HARTZELL PROPELLER INC.  
**SERVICE BULLETIN**

HC-SB-61-227

**Propeller - Hub Inspection**

This page transmits Revision 5 to Service Bulletin HC-SB-61-227.

**Hub Identification**  
**Figure 2**

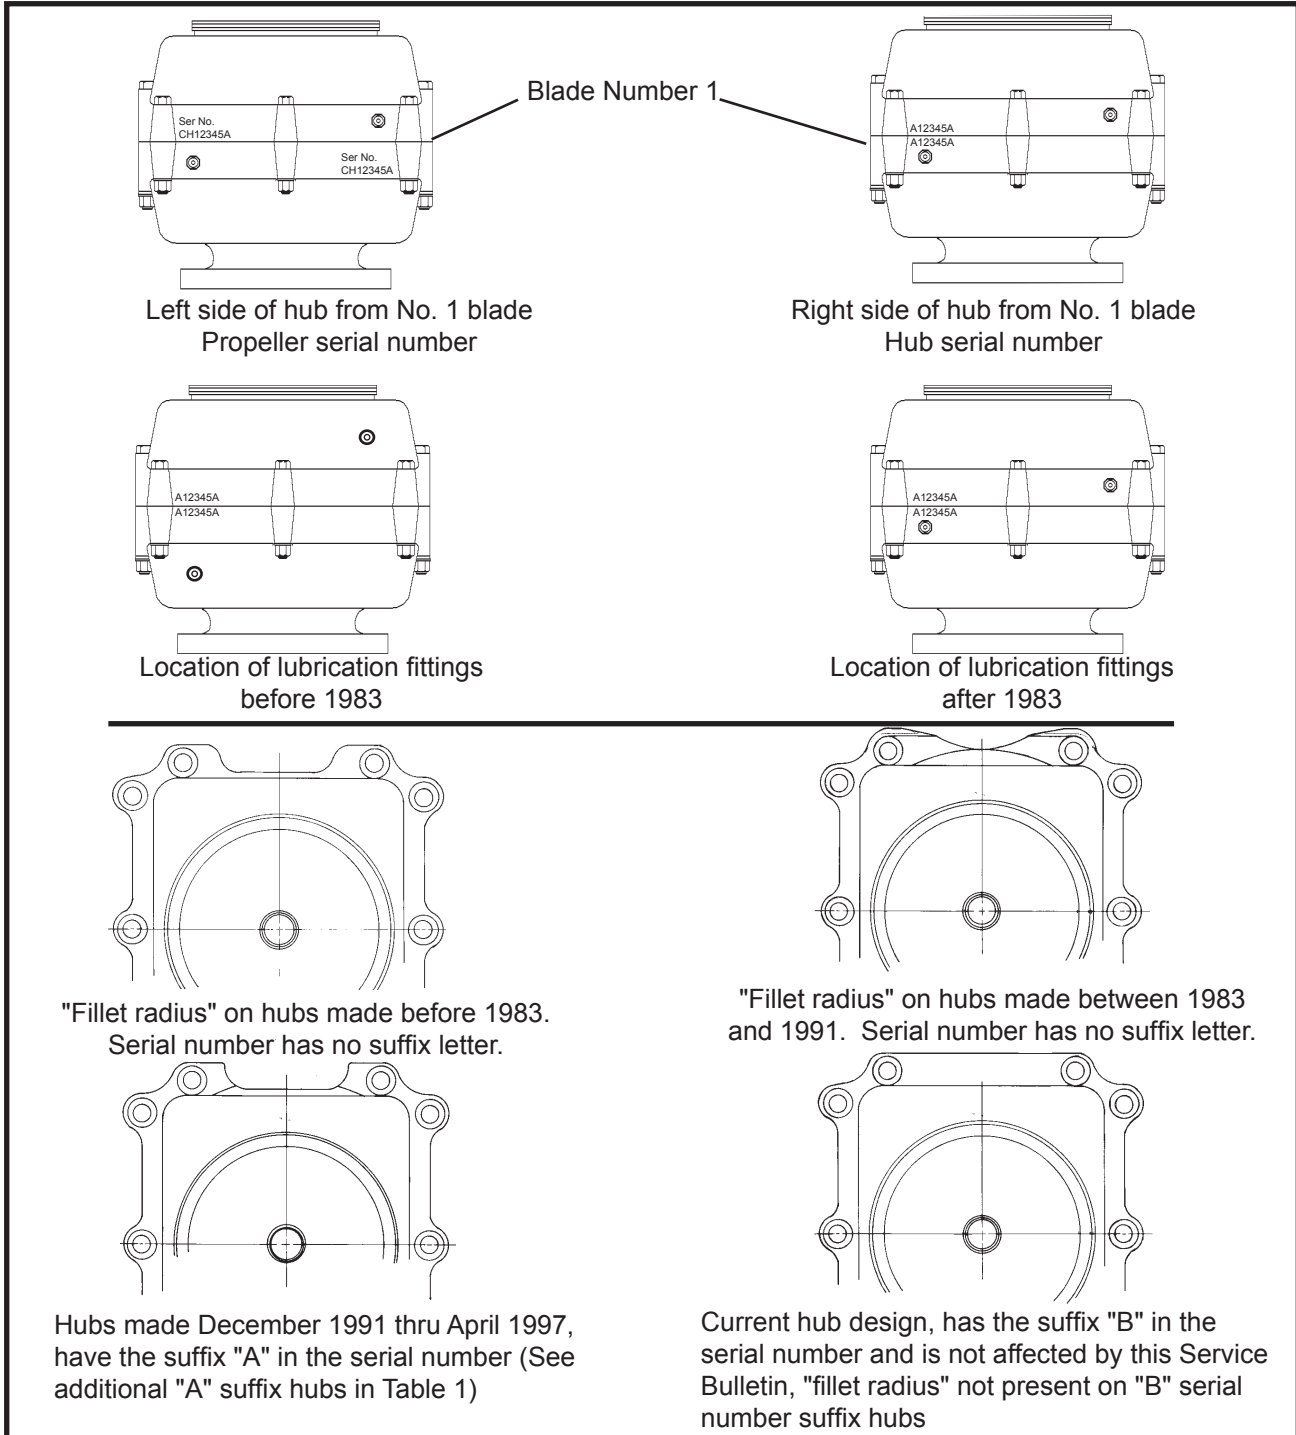
NOTE 3: Propellers manufactured after April 1997 have a suffix letter "B" at the end of the hub and propeller serial numbers. Hub serial numbers without suffix letter "A" or "B" were manufactured before 1991 and can be identified by two different styles of the fillet radius as shown in Figure 2. "A" suffix serial number hubs can be identified by the fillet radius shown in Figure 2. These hubs have been produced from December 1991 through April 1997. Additional "A" suffix hub serial numbers are shown in Table 1. These hubs have been modified and differ slightly in appearance from those shown in Figure 2. "B" suffix serial number hubs are identified by the lack of a fillet radius at the blade socket shown in Figure 2. These hubs are current production made since April 1997. The "E" suffix letter is added to the hub serial number to indicate that the initial eddy current inspection has been performed and a repetitive eddy current inspection is required.

**Socket Fillet Radius Inspection**  
**Figure 3**

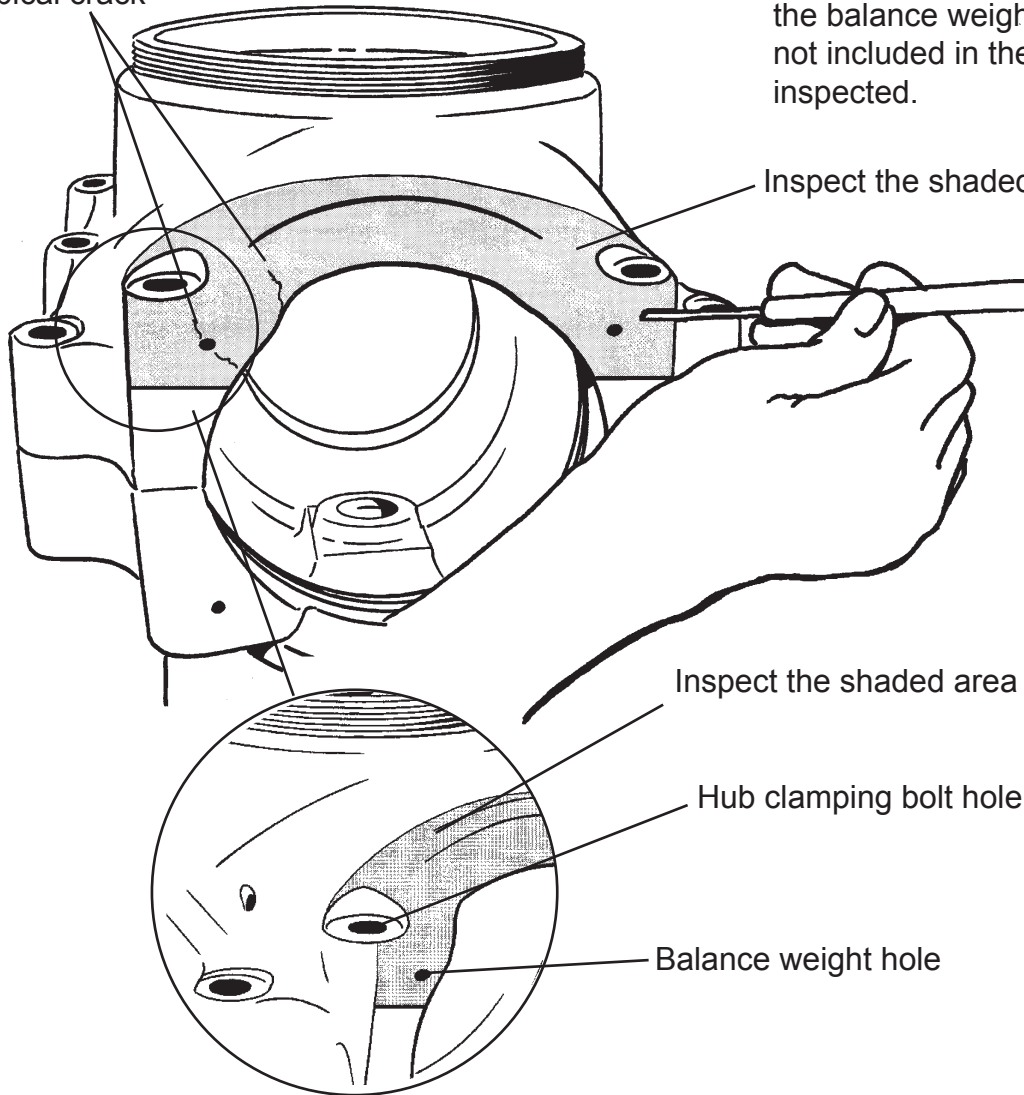
NOTE: The hub clamping bolt holes and the balance weight holes are not included in the areas to be inspected.

Circled areas encompass the "fillet radius", must be inspected.

Hubs with no "A" or "B" serial number suffix, and hubs listed in Table 1: Inspect highlighted area on each blade socket (forward hub half) during on-wing inspection, and four points (both hub halves) during overhaul inspection.

- (g) Perform eddy current inspection in accordance with procedures in Hartzell Standard Practices Manual 202A. See Figure 3.
